July 29, 2014

RE: Comments on the Draft Bay Delta Conservation Plan and DEIS/DEIR

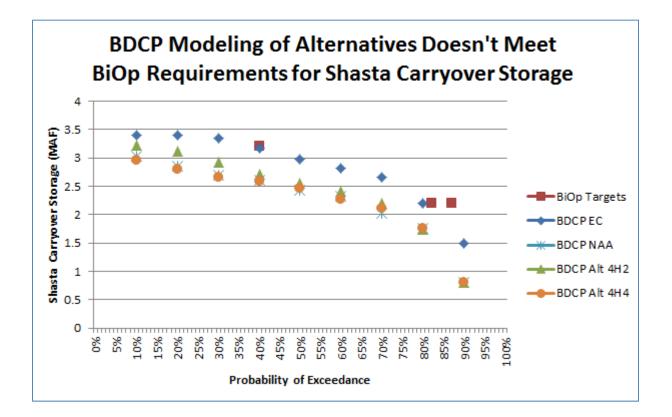
The DEIS/DEIR states that, "If necessary, comparisons of model results against threshold or standard values should be limited to comparisons based on cumulative probability distributions." DEIS/DEIR Appendix 5A, Section C, at C6. Yet the exceedance of a standard should result in probabilities close to zero, and the lack of such output indicates that the models are inaccurate.

intention" of meeting D-1641 standards. This does not seem to be the case in certain dry years such as 2013 and 2014, and the effects of similar relaxations of water quality standards and other environmental requirements in the future are not analyzed or disclosed in the DEIS/DEIR, despite the fact that such changes are reasonably foreseeable. According to the 2014 independent panel review of delta outflow and other stressors, "The average measured Delta outflow during fall 2013 was approximately 2,000 cfs, which failed to meet the Board's minimum outflow requirement of 3,000 to 3,500 cfs for fall months of a critically dry year." DSP Outflows Review Panel Report 2014 at 15. Likely future waivers and relaxations of standards modeled in BDCP are yet another example of how the modeling of BDCP fails to accurately assess likely environmental impacts.
